Architects and Engineers Investigating Destruction of WTC Skyscrapers on September 11

Technical Analysis

NIST's final report on the collapse of World Trade Center Building 7, issued in November 2008, has many flaws, including blatant fraud.

Part 3 (below) was originally published on August 22, 2013.

Figure 12-4. Typical composite floor construction detail (along weak direction).

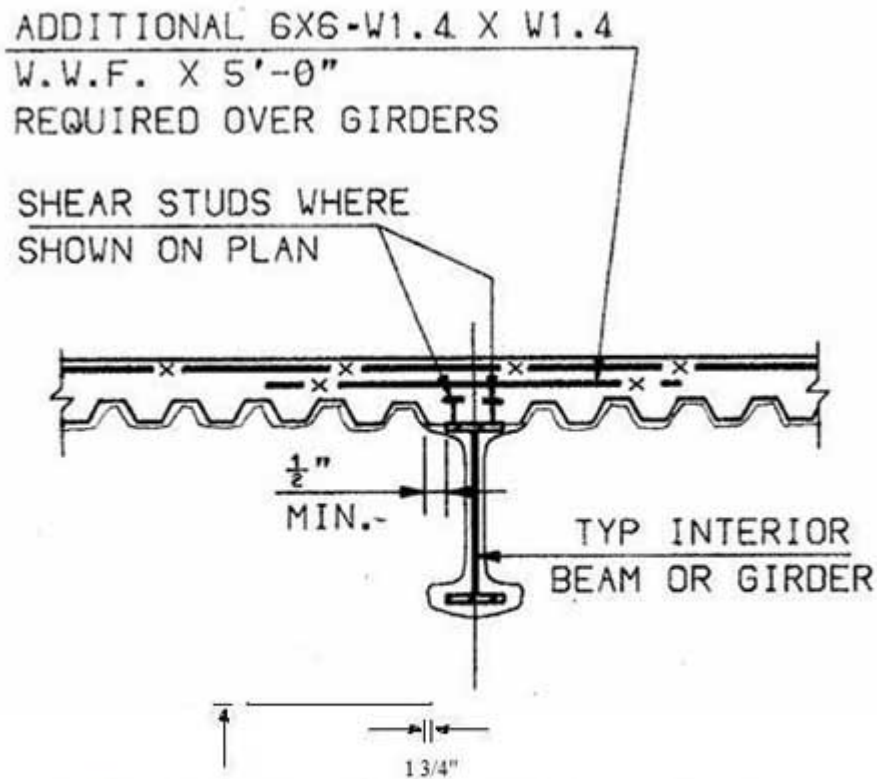
“Most of the beams and girders were made composite with the slabs through the use of shear studs.* Typically, the shear studs were 0.75 in. in diameter by 5 in. long, spaced 1 ft to 2 ft on center.** Studs were not indicated on the design drawings for many of the core girders.” — [NIST June 2004 Progress Report, Appendix L, pages 6-7 \[PDF pages 895-896\]](#)

*NCSTAR 1-9, Vol. 2, Figure 12-4 (below)

Drawing S-8

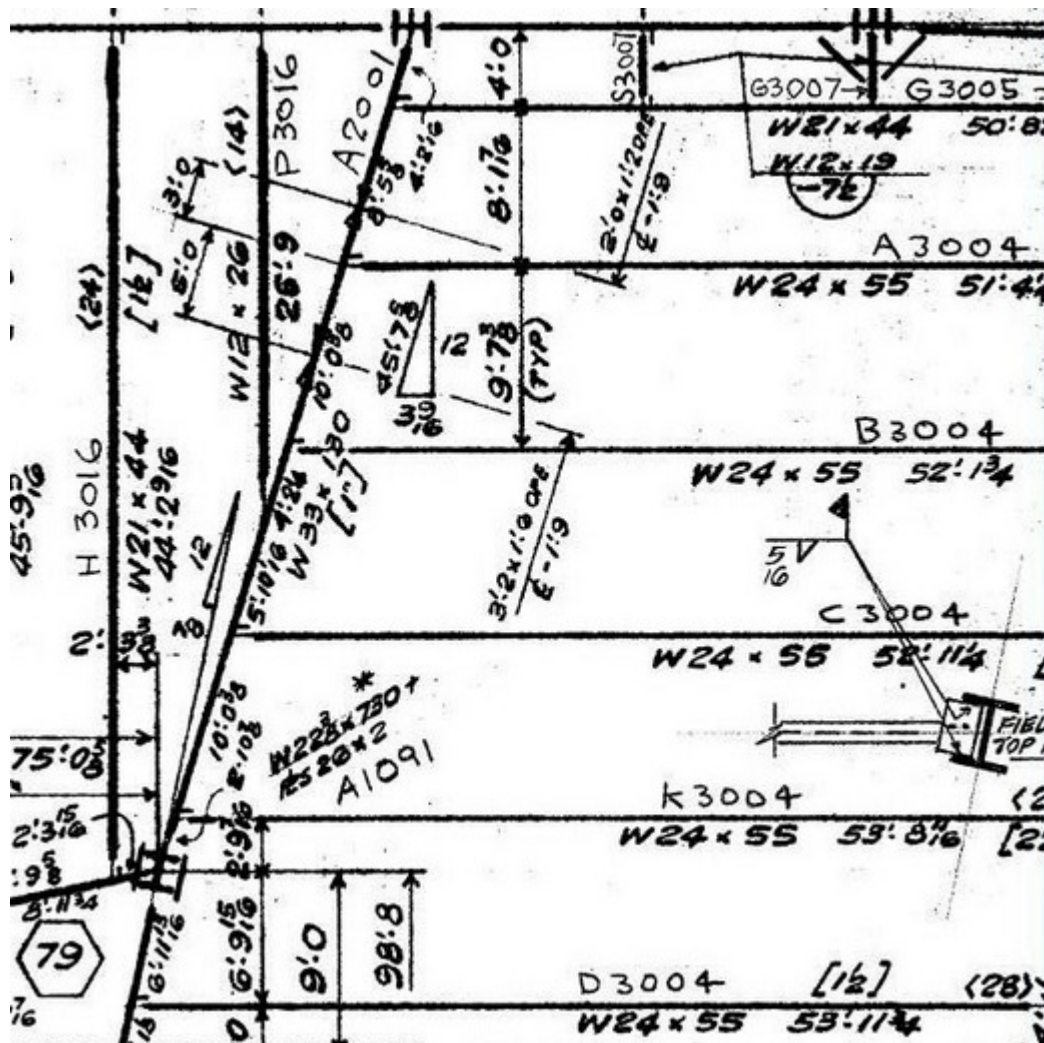
Structural engineer Ron Brookman found that the Salvarinas "Fabrication and Construction Aspects," a document that outlines the basic structural system of WTC 7, shows 30 shear studs on the girder in question (see page 20 of the Seven World Trade Center link above the next graphic).

Has Revision I been redacted/scrubbed here?

NIST used a drawing without the shear stud notation in the final report on WTC 7. The space with the missing shear stud notation was instead used for the angle notation.

NIST did not release the "As built" drawings, which no doubt have the shear studs on the girder between columns 44 and 79.

10TH FLOOR FRAMING PLAN

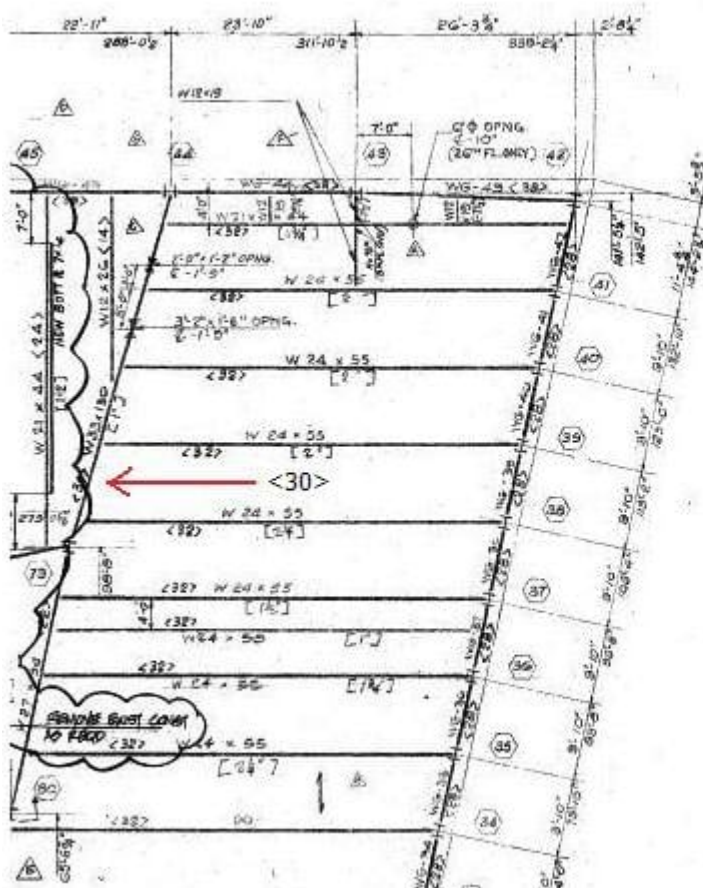
A FOIA release in 2012 contained drawings that show <30> shear studs on that girder on Floor 10 and Floor 20. It is simply not consistent or logical to have shear studs on the girder on some floors but not on other floors. See drawings S-8-10 and S-8-20 below.
